# Sampling Rate Change for OFDM mode

IEEE S802.16a-02/43

This presentation illustrates Comment in LB4a

# ACI and Orthogonality.

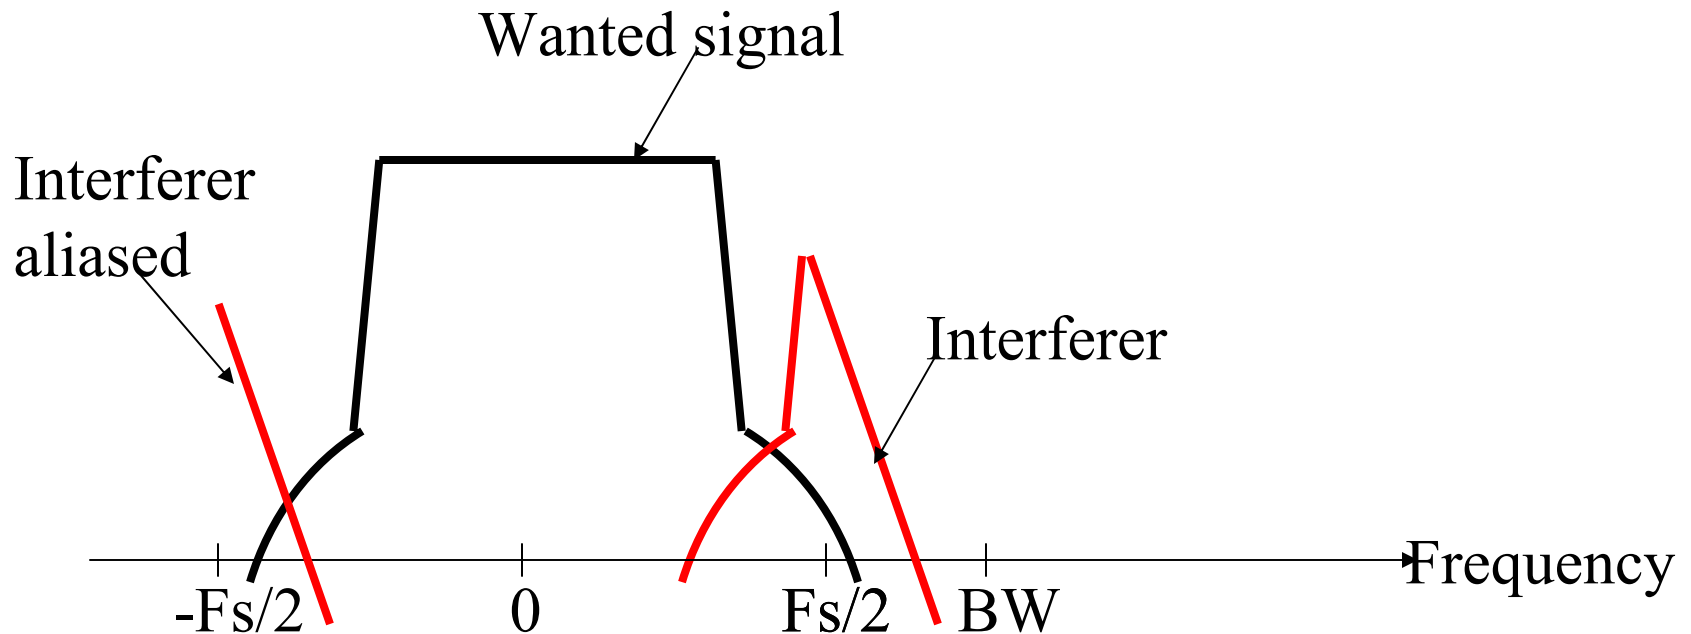
- With  $8/7$  the channel spacing is always an integer number of subcarriers.
  - Ch spacing =  $(7/8 * F_s) / (F_s/256) = 224$  subc.
- With  $7/6$  it is not
  - Ch spacing =  $(6/7 * F_s) / (F_s/256) = 219.48$  subc.
- Reduces Adjacent Channel Interference

- After Filtering and sampling

# ACI and Orthogonality.

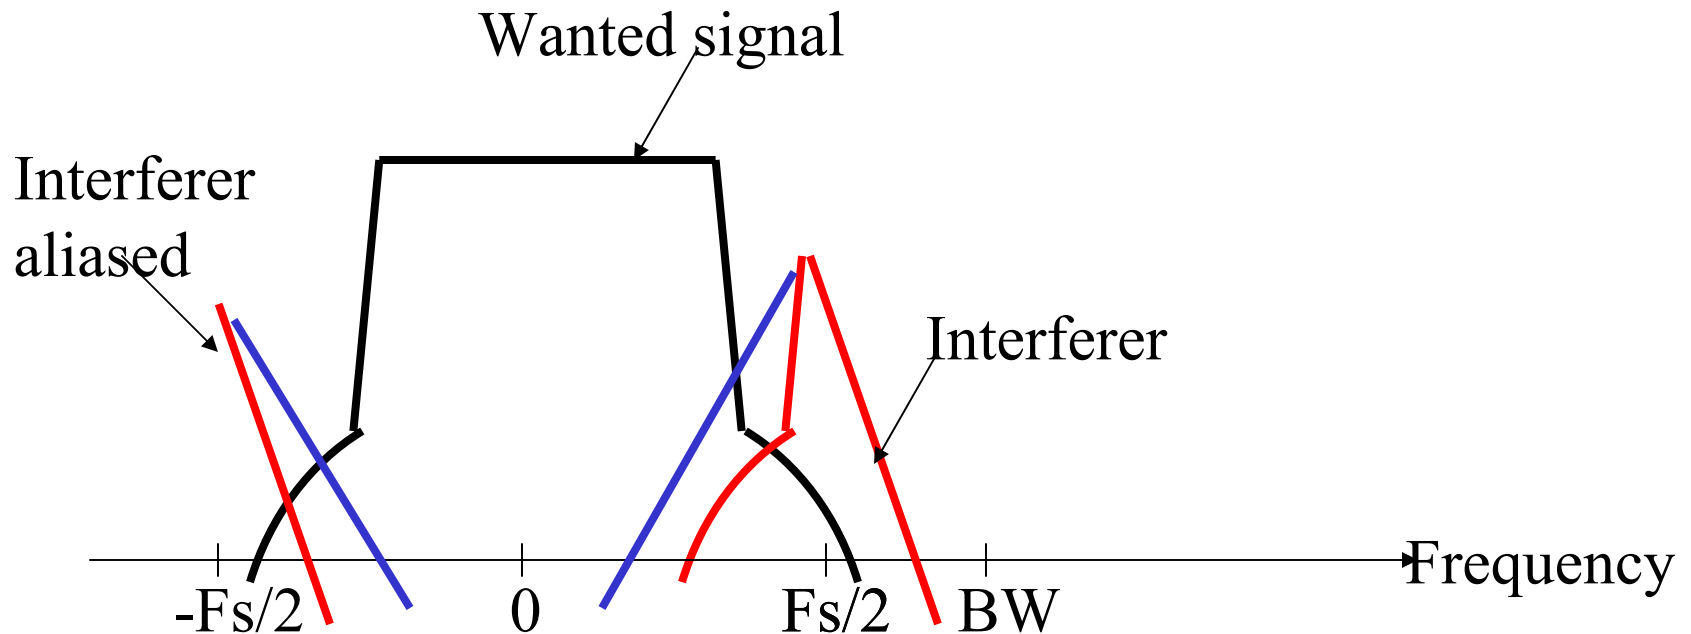
- If interferer is not in same subcarrier grid:
- Interferer effectively convolved with Sinc function
- Out of band interference leaks in => Increase ACI
